Design Review Board Meeting
Tuesday, September 23, 2025 - 5:00 PM
AGENDA

Design Review Board
Tuesday, September 9, 2025 - 5:00 PM
MINUTES

View proof for Freya Dimensional Logo, 25mm PVC & Clear Acrylic, Black, 96x28 (1) SS

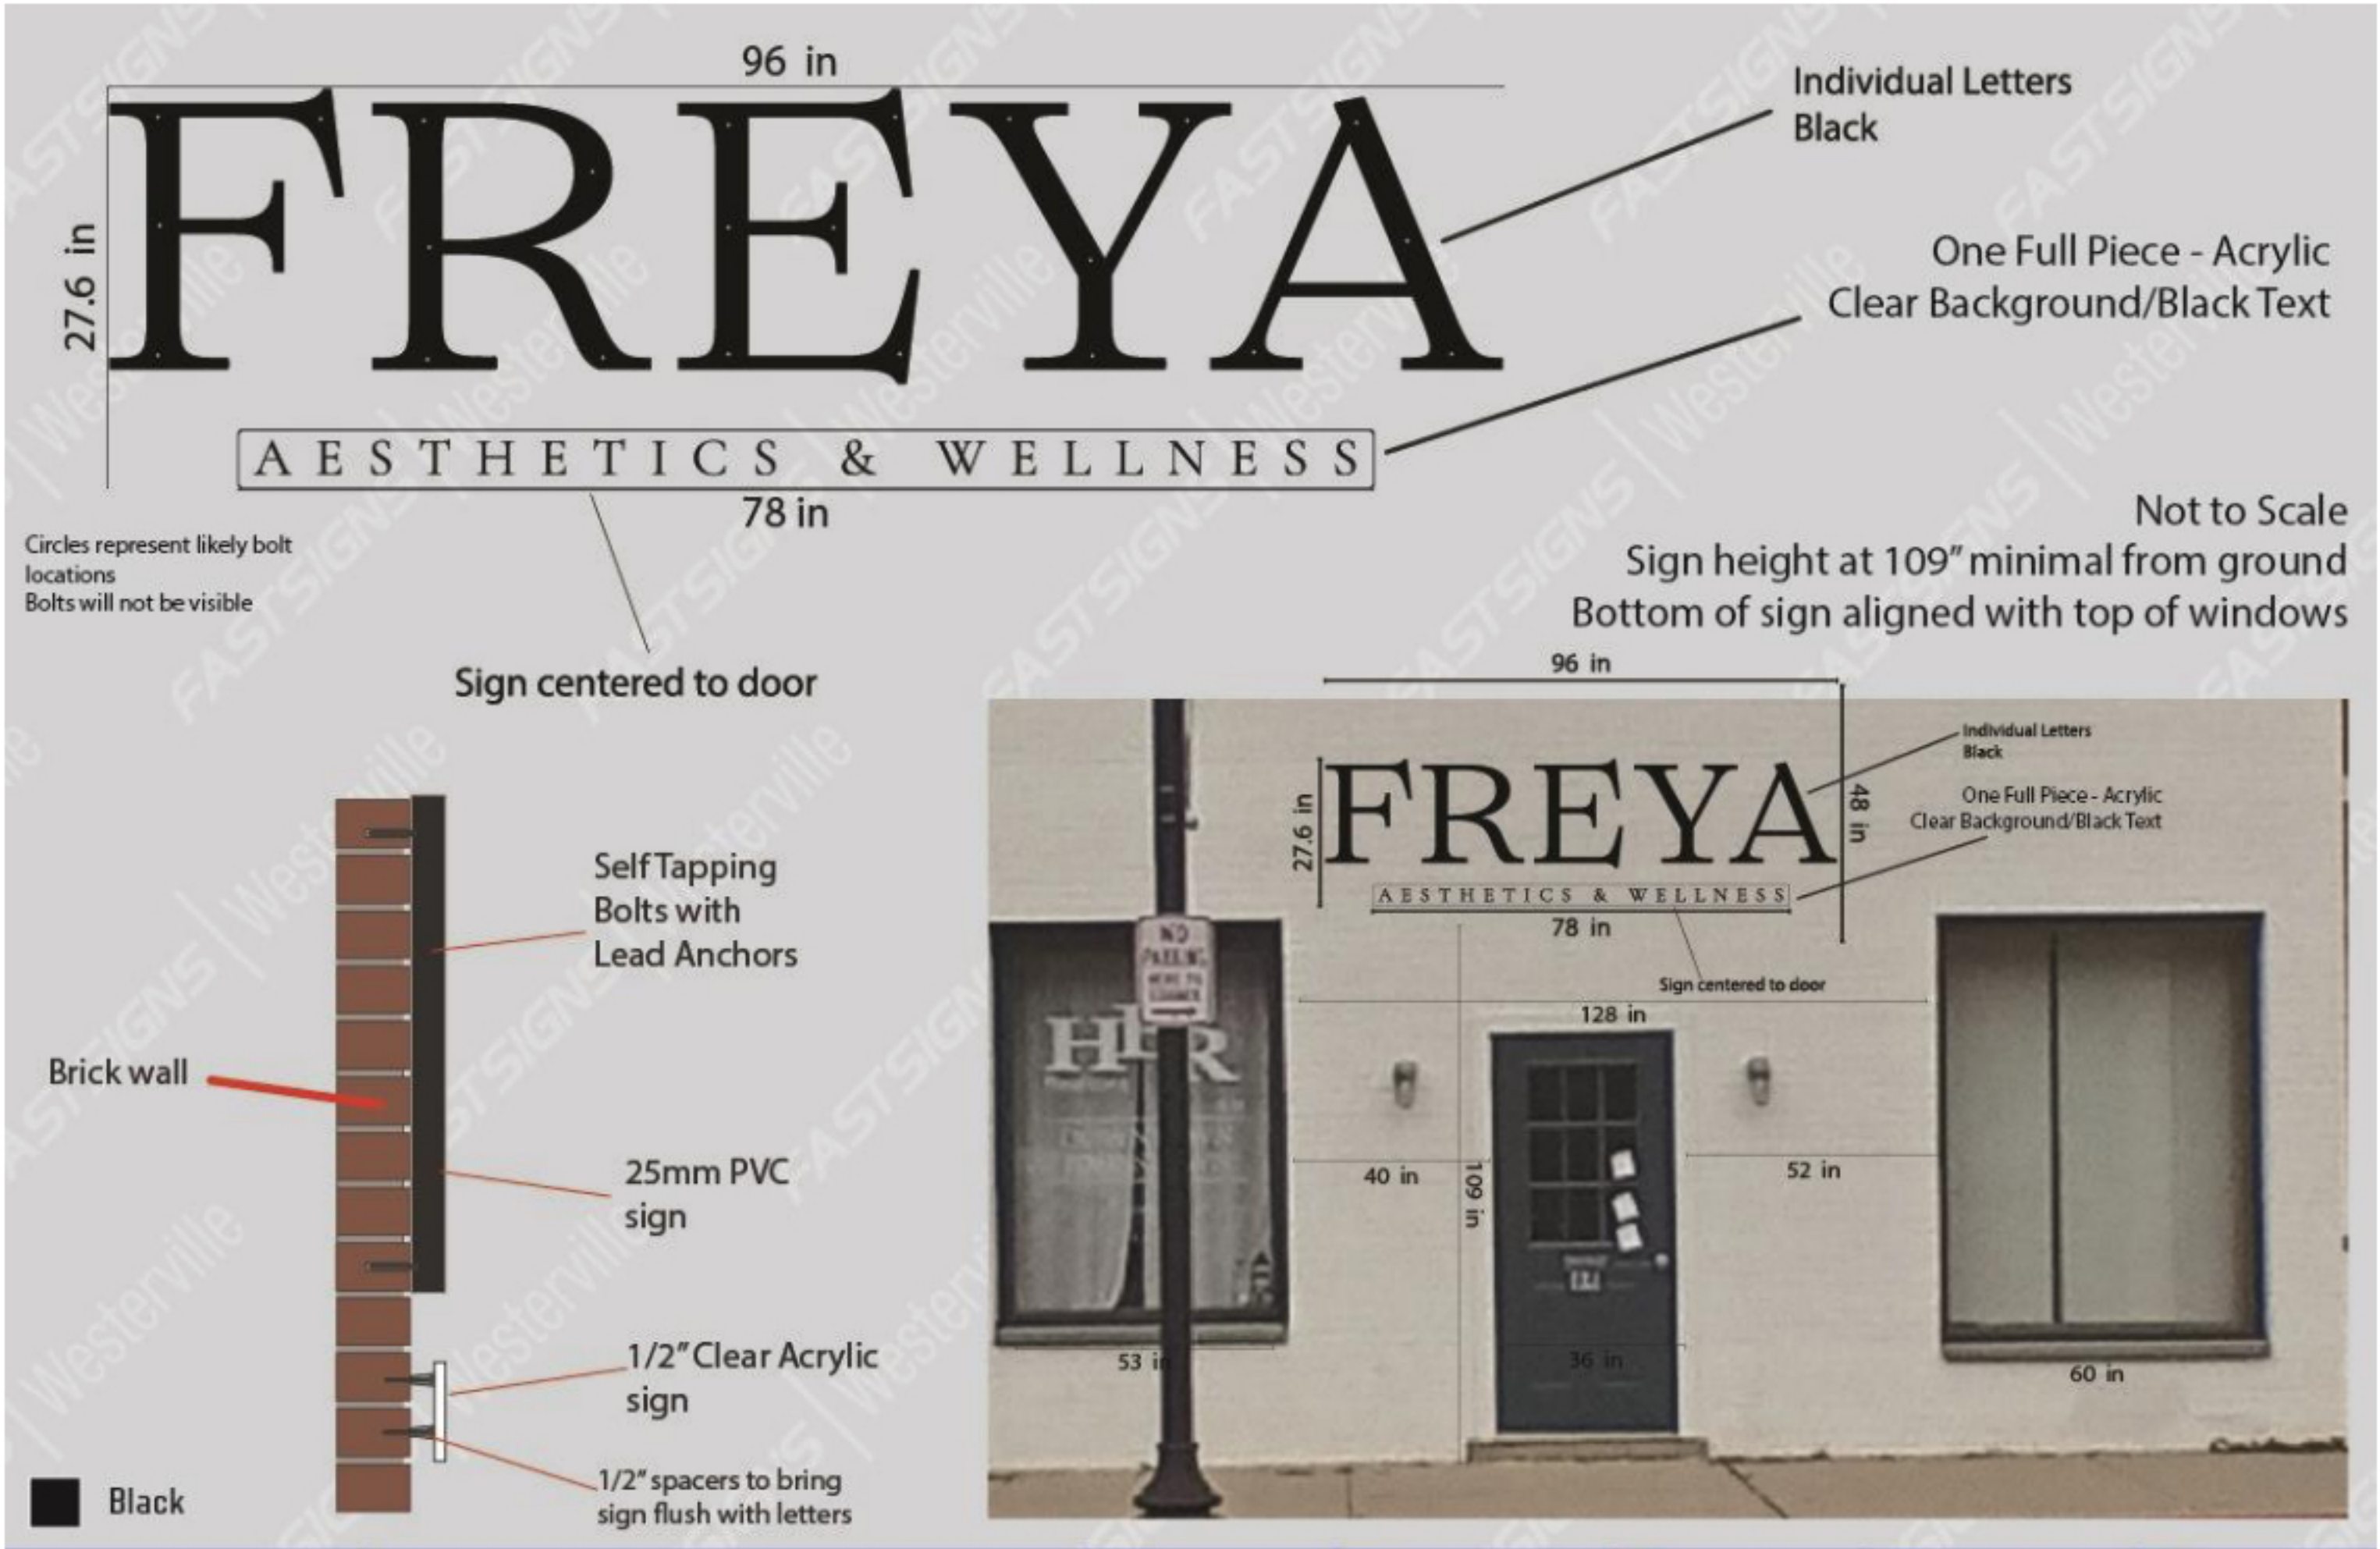
Board review of the application submitted. The application presented shows that the sign rendering is not to scale, Dustin Gerkin said he doesn't hate the scale that is shown, but he has a feeling that if the applicant comes back with a to-scale rendering it will look way too wide. Discussion on the black letters, applicant stated they were a matte finish. Discussion on how the letters will be applied to the brick. Dustin Gerkin said he likes the look of the end of the "F" and end of the "A" lining up with the exterior sconces, so he would just pull that measurement. He would also like to see the bottom of the "Aesthetic & Wellness" line up with the top of the frame of the adjacent windows.

1. Bring material samples for the black letters and the acrylic panel.
2. Bring two versions back, one to scale with the eight feet wide and one as shown with those measurements and alignment discussed for A and Y lining up with sconces and to lower the clear panel to line up with top of windows
3. Use spacers behind the clear acrylic
